**INTEROFFICE MEMO
PLANNING AND COMMUNITY
DEVELOPMENT DEPARTMENT**

SUBJECT: 430 and 440 State Street
Parcel Numbers 12-03-220.200 and 12-03-220.300
Zoning – Urban Mixed Use
Petition for an Area Variance to increase the maximum unbuilt frontage in an Urban Mixed Use District
File #617

UPDATE (April 3, 2026): At the March 18, 2026, meeting, the ZBA tabled this application. This is one of four concurrent Variance requests related to this development proposal. The ZBA did not request additional information specifically related to this Variance request.

Sheet Number
CP1

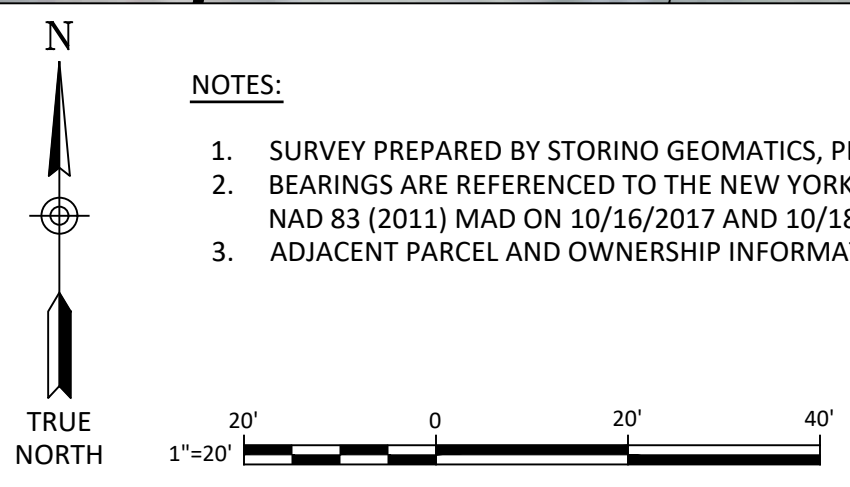
However, the following characteristics of the Site Plan drawing, as submitted with this ZCC application, are Nonconforming:

Section §310-21 (5)(A) of the Zoning Ordinance allows a maximum 12-foot front-yard setback in the UMU District. The Site Plan, as submitted, depicts a 66.7-foot front-yard setback. This condition could be legal only with the relief of an Area Variance granted by the Zoning Board of Appeals.

Section §310-21 (D)(10) of the Zoning Ordinance allows a maximum of 24 feet of unbuilt frontage in the UMU District. The applicant proposes a Subdivision and subsequent assemblage (a process colloquially known as a “lot line adjustment”) that would create a subject parcel with 198 feet of frontage on State Street. The proposed primary Café structure and the proposed shed are both depicted as 16 feet wide, an aggregate of 32 feet of built frontage, leaving 166 feet of unbuilt frontage. This condition could be legal only with the relief of an Area Variance granted by the Zoning Board of Appeals.

Section §310-50 (A) of the Zoning Ordinance states that *“Pedestrians must be able to enter the establishment from the parking lot or sidewalk without crossing the waiting or exit lane.”* The Site Plan, as submitted, depicts the drive-through exit lane passing between the primary structure and the State Street sidewalk, directing pedestrians across this exit lane via a striped internal crosswalk to access the Café. This condition could be legal only with the relief of an Area Variance granted by the Zoning Board of Appeals.

Section §310-83 (C)(1) of the Zoning Ordinance requires a minimum 15-foot landscaped buffer along street Rights-of-Way (ROW). In the UMU District, where the maximum building setback is 12 feet, this requirement decreases to the width of the setback area when the setback conforms. However, with the building proposed for a 66.7-foot front-yard setback, the full 15-foot requirement for landscaping along the ROW applies, and the proposed 6.6-foot buffer depicted on the Site Plan could only be legal with the relief of an Area Variance granted by the Zoning Board of Appeals.

Section §310-83 (F) of the Zoning Ordinance requires a minimum 8-foot landscaped buffer around the perimeter of any parking lot, exclusive of driveways. The Site Plan, as submitted, depicts no landscaped buffer between the seven proposed parking spaces and the eastern property line shared with 454 State Street. This condition could be legal only with the relief of an Area Variance granted by the Zoning Board of Appeals.
